November 7, 2017

RE: Proposed Aquifer Exemption, Basal Sespe Formation
Sespe Oil Field, Ventura County, California

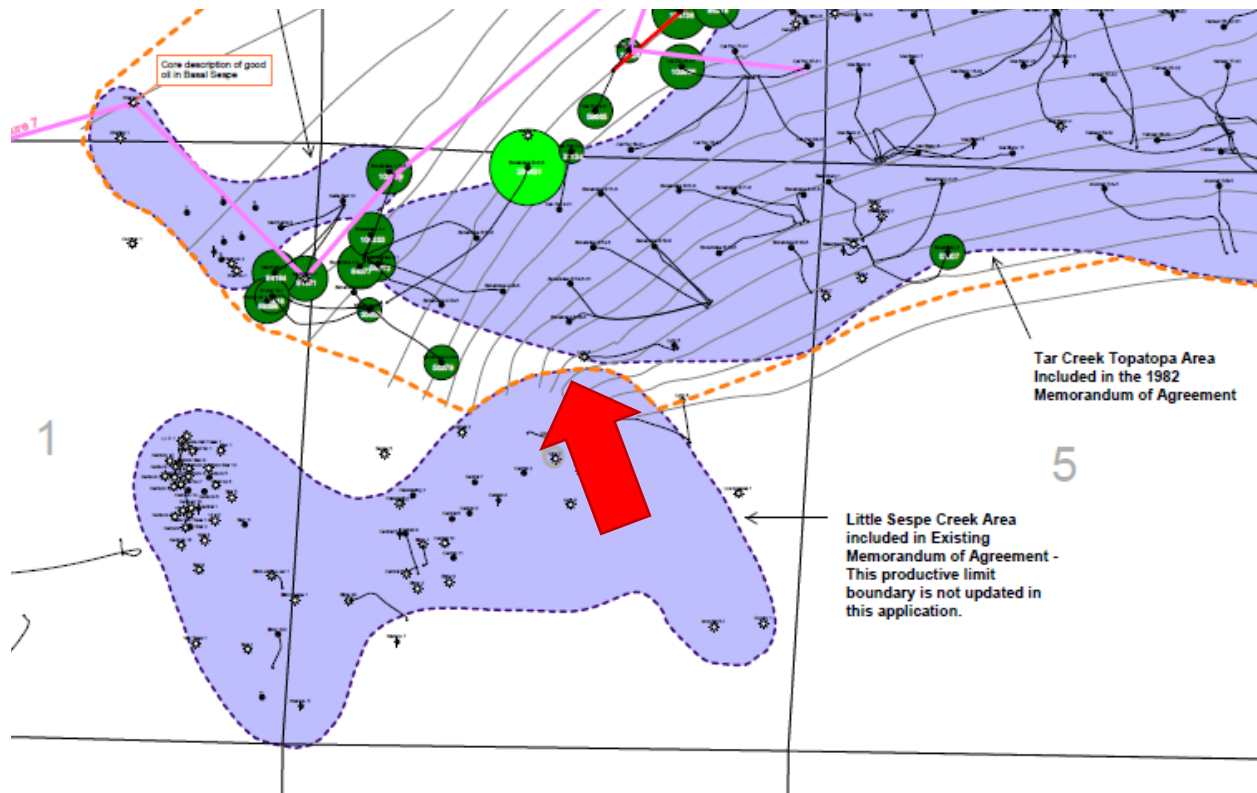
Finally, the proposed exemption boundary at the southwestern tip is drawn in a manner that raises doubts about whether that section is geologically contained. Here – as shown in Figure 4 – the boundary is drawn to exclude the Little Sespe Creek Area, along with a notation stating “Little Sespe Creek Area included in Existing Memorandum of Agreement – This productive limit boundary is not updated in this application.” Simply drawing the new boundary to exclude an existing exempt area does not provide an adequate basis for granting the AE Request.

Recommendation: We urge your agencies to require Seneca to conduct additional pressure surveys inside and outside of the proposed exemption area, and to provide a detailed description of the survey methods and protocol. In addition, we recommend that conditions be placed upon any aquifer exemption to ensure that pressure and water quality monitoring are implemented immediately. In addition, Seneca should submit a plan for how it intends to maintain the pressure gradient, in the likely event that its operations in the Sespe Oil Field change or cease over time.

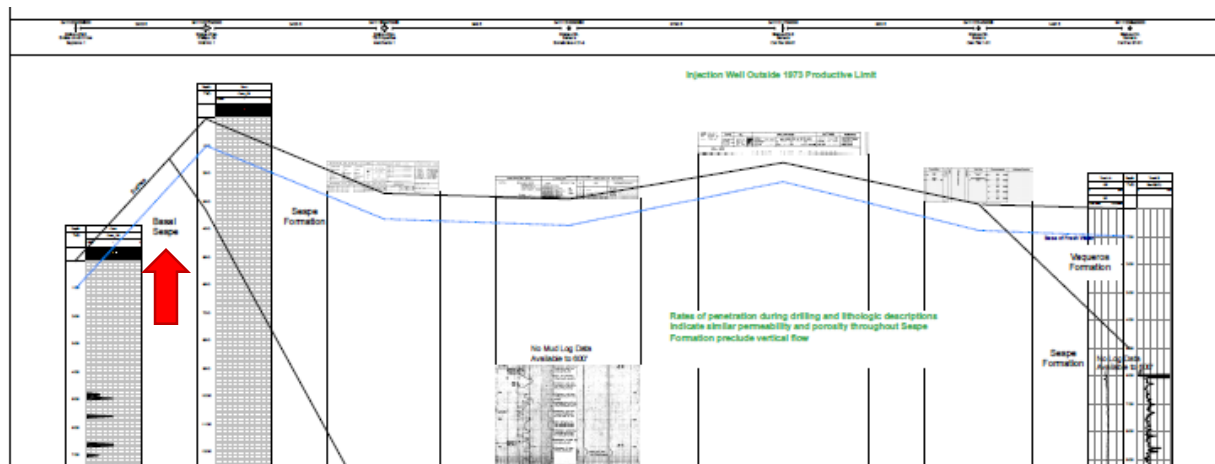
Figure 7 in the AE Request indicates that the Basal Sespe intersects the surface. Specifically, the area between wells Supreme 1 and Phillips Oil Well No. 1 shows the Basal Sespe extending to the surface. This is significant because (1) the cross-section is located approximately one-half mile from Sespe Creek, and (2) encompasses a tributary to Sespe Creek. We are concerned that injected wastewater could migrate to this portion of the aquifer and contaminate the base of fresh water that underlies the area, as well as the surface water in Sespe Creek and its tributaries.

Recommendation: Disclose more information about the Basal Sespe surface geology, base of fresh water, and surface waters in and near the proposed exemption area.

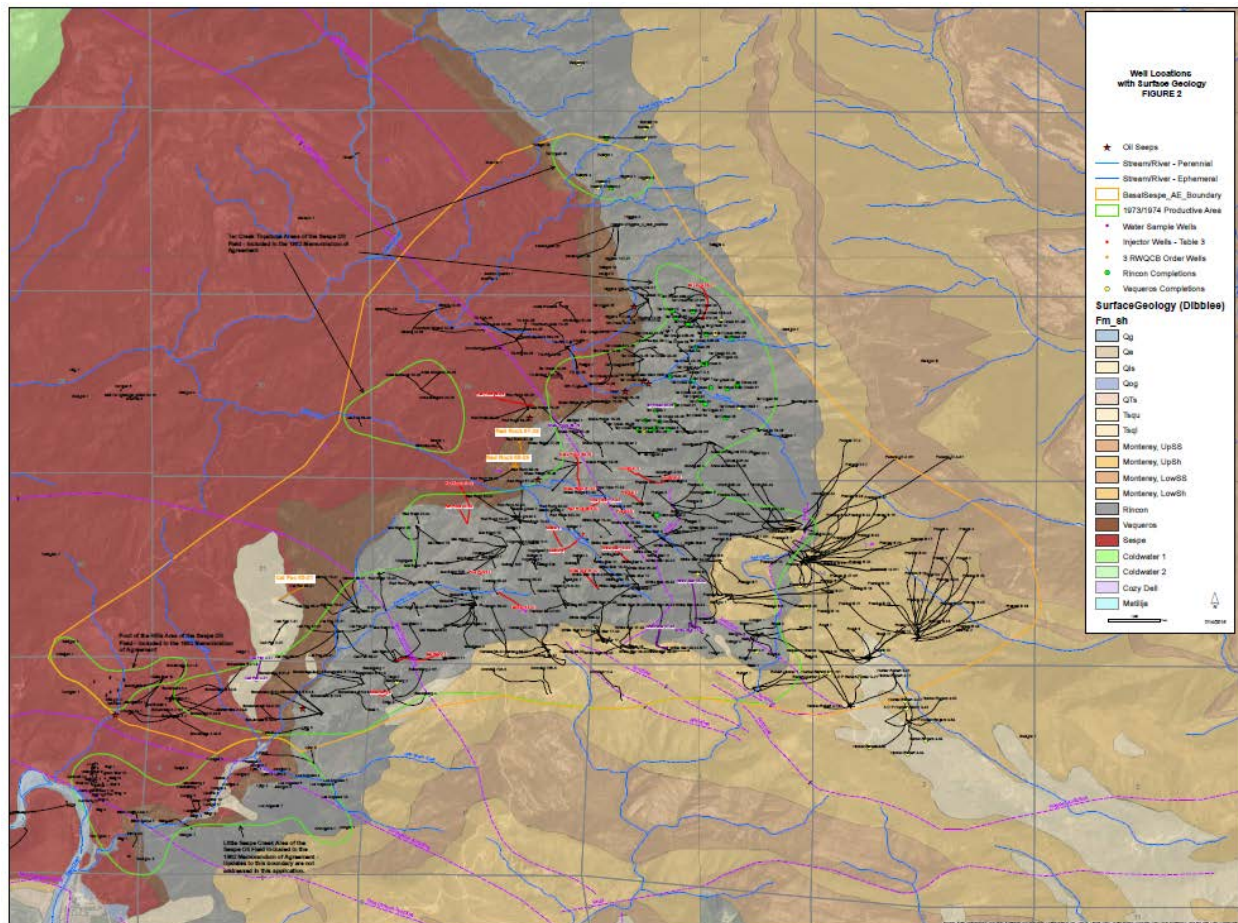
There are no defined barriers (e.g. confining silt or clay layers) precluding fluid flow between the Basal Sespe zone, the Sespe zone above, and the Coldwater zone below. Similarly low porosities and permeabilities amongst the layers are supposed to prevent fluid flow. However, without definite barriers, interactions between these zones can occur. Moreover, there is not a defined boundary between the Basal Sespe and the Sespe zone, so injection in the Basal Sespe zone can potentially impact the Sespe zone, which also intersects the surface.

Given the risk of potential surface water contamination in this area, it seems prudent to require Seneca to provide more information about the intersection of the Basal Sespe with the surface geology, and the relationship between these areas and Sespe Creek, and tributaries thereto.
